TECHNICAL SERVICE BULLETIN

ENGINE 104.990, 119.970/971/974/975 WITH ASR - REPLACEMENT OF ELECTRONIC ACCELERATOR CONTROL MODULE

Model(s): 1992 Mercedes-Benz 400 E, 500 E, 300 SE, 400 SE, 500 SEL

Bulletin No.: 30/4

Fig. 1: Electronic Accelerator Control Module Identification Sticker (Located On Side Of Module)

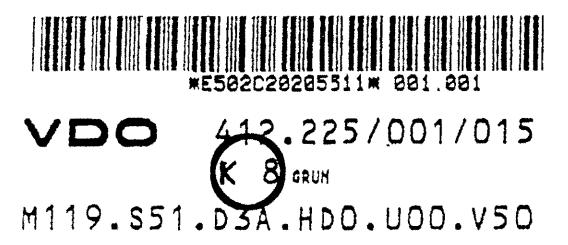
The new control modules have a production date of 16/92 (week 16 of 1992) or later stamped in blue. An additional way to identify the new modules is to check the "K" number, (circled in Fig. Fig. 1.)

Model	Sales Designation	"K"-number must be:
124.034	400 E	K11 or greater
124.036	500 E	K10 or greater
140.032	300 SE	K12 or greater
140.042	400 SE	K10 or greater
